Gachsaran Polymer Industries Company	Gachsaran Polymer Industries Company HDPE Plant		
	General Arrangement Drawing (2D) (Tie-In Points , Skid Dimensions & Orientation, Including Instrument, Junction Box and Local Panel Location Layout & Instrument Cable routing.) for Refrigerator Package	 	
PO No.: GPIC-PT-MA-PO-000-3029	Document Number: VD-GPIC-MA-3029-3029-0062	Rev. 05	Page 1 of 12

General Arrangement Drawing (2D) (Tie-In Points , Skid Dimensions & Orientation, Including Instrument, Junction Box and Local Panel Location Layout & Instrument Cable routing.) for Refrigerator Package

MA-G0:
 Generally this document could be considered as code-2, but The above comment of Piping department should be considered as EIED's concern on this matter. if vendor requires a meeting, it could be arranged by vendor's request.

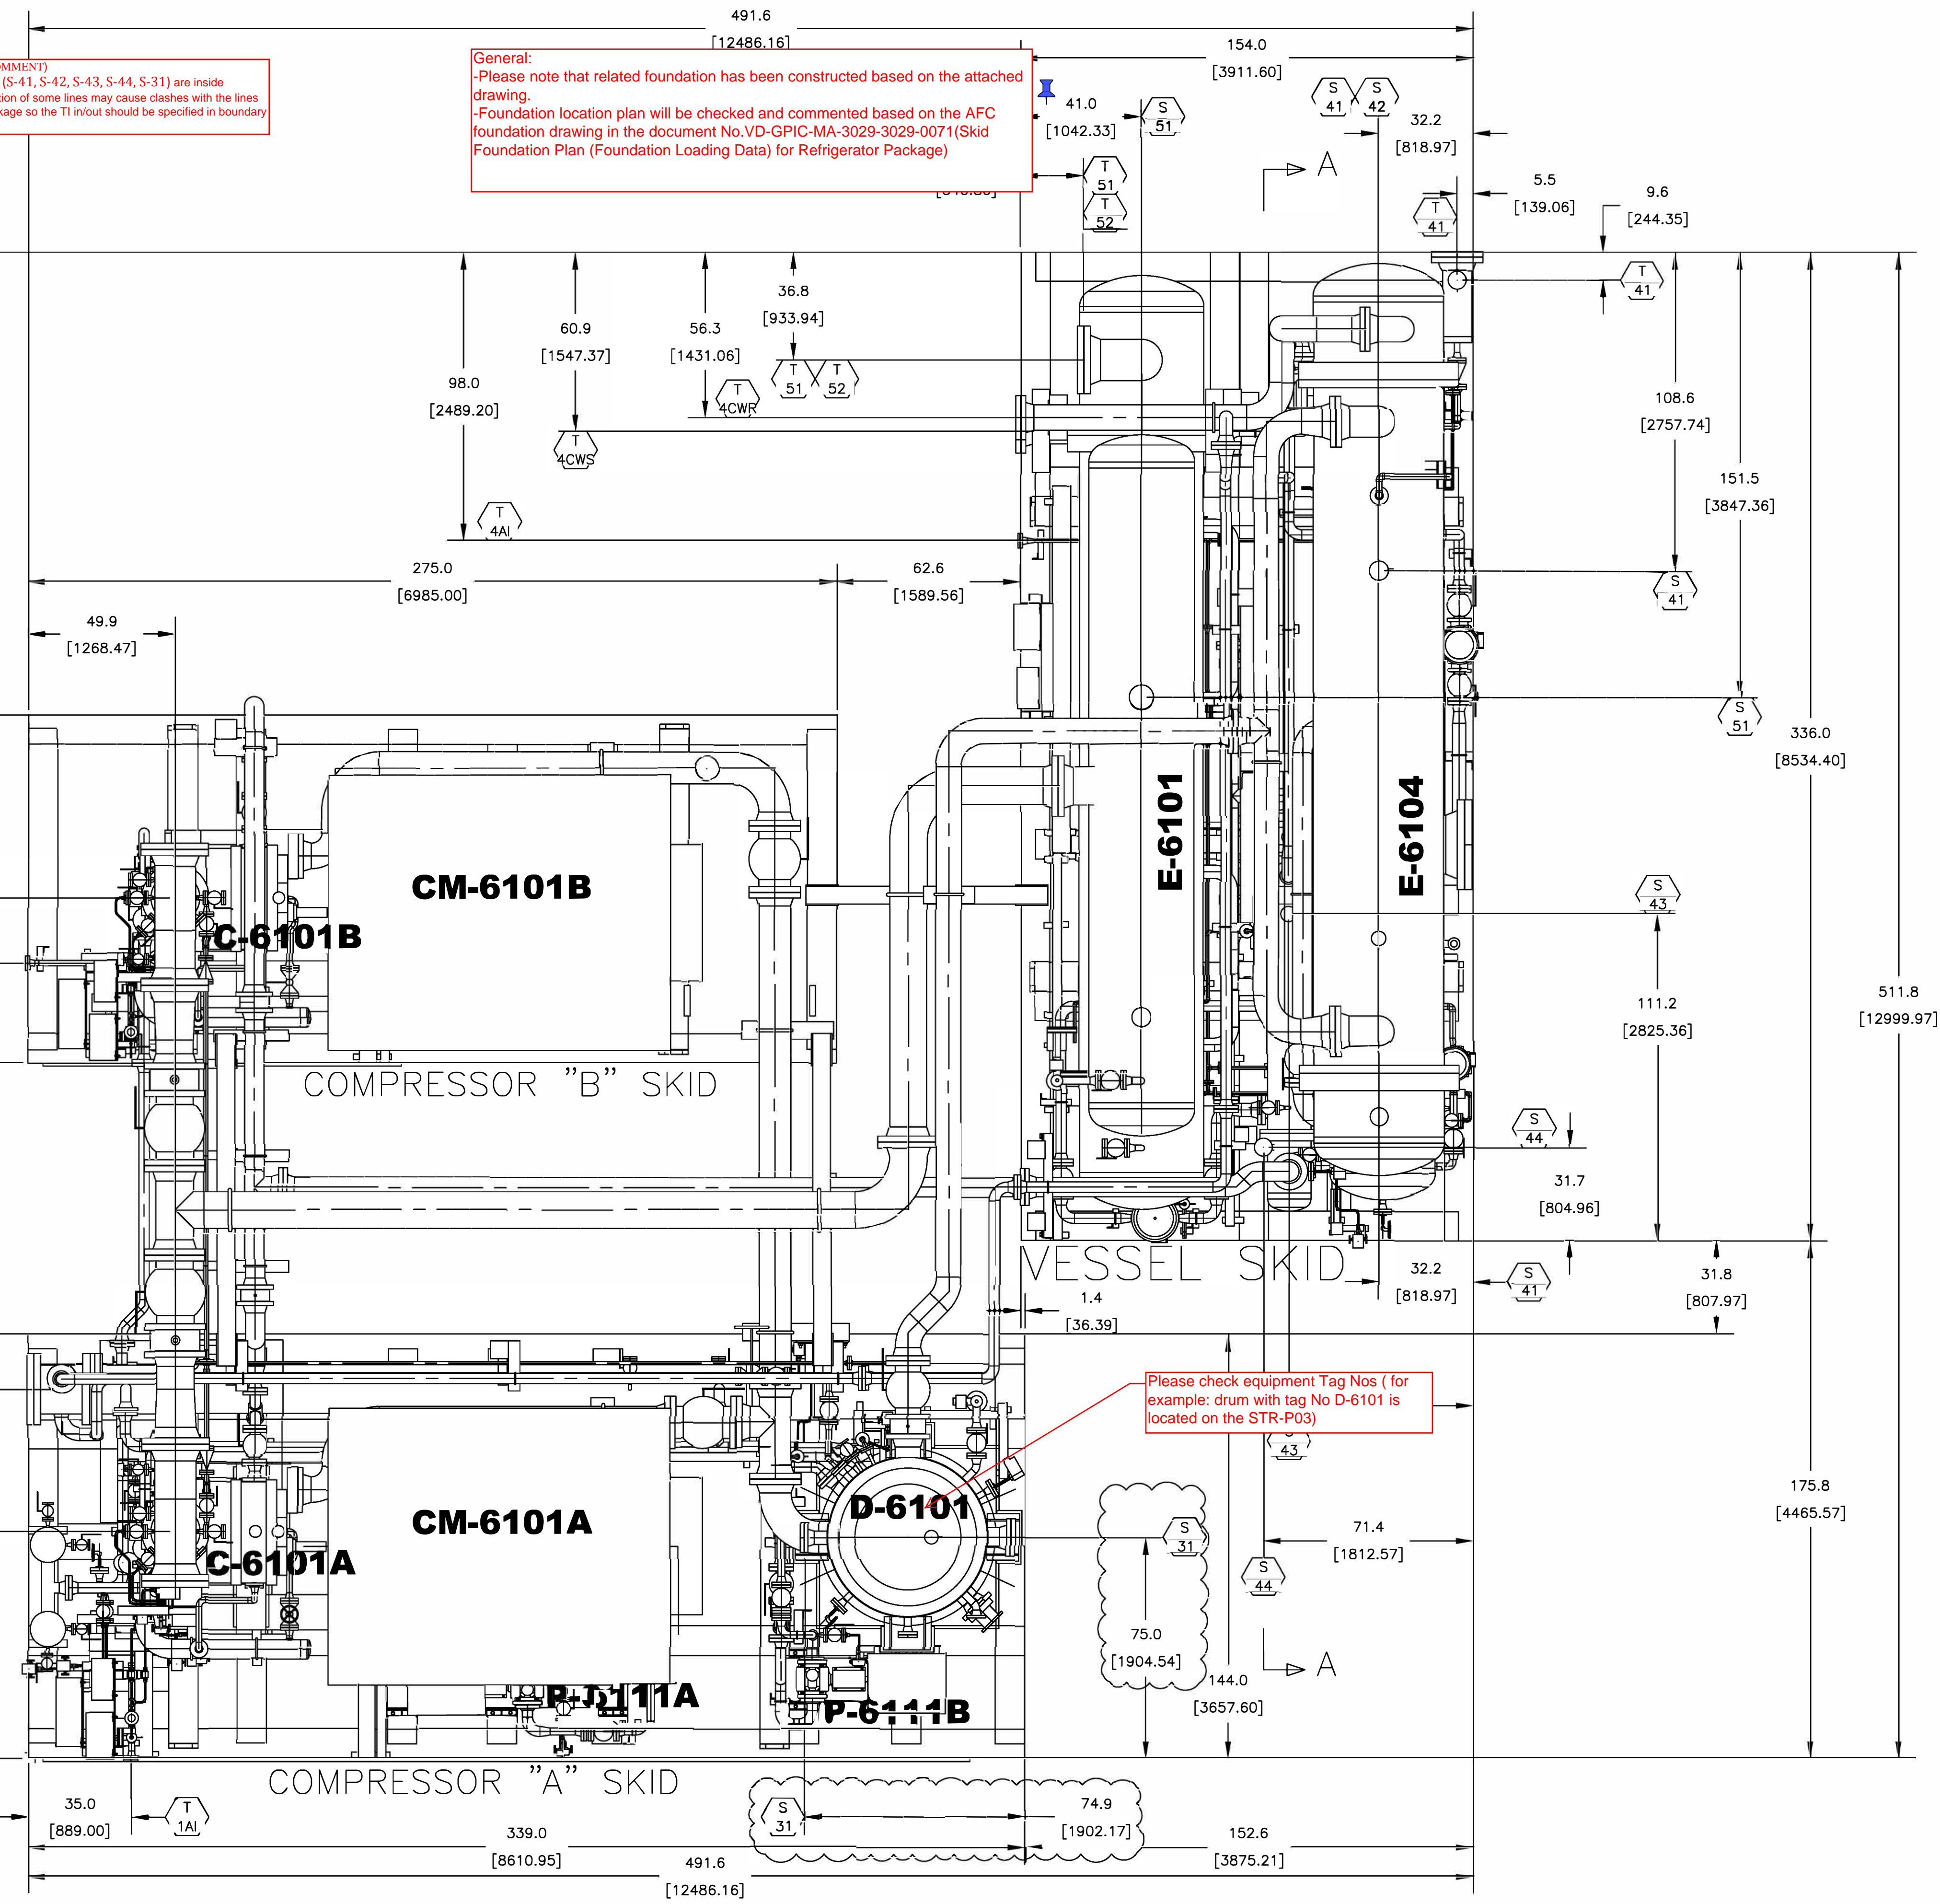
PI COMMENT: (REPEATED COMMENT)
-Since location some of TI-IN's (S-41, S-42, S-43, S-44, S-31) are inside package and the direct connection of some lines may cause clashes with the lines and equipments inside the package so the TI in/out should be specified in boundary skids.

General:
-Please note that related foundation has been constructed based on the attached drawing.
-Foundation location plan will be checked and commented based on the AFC foundation drawing in the document No.VD-GPIC-MA-3029-3029-0071 (Skid Foundation Plan (Foundation Loading Data) for Refrigerator Package)

Please check equipment Tag Nos (for example: drum with tag No D-6101 is located on the STR-P03)
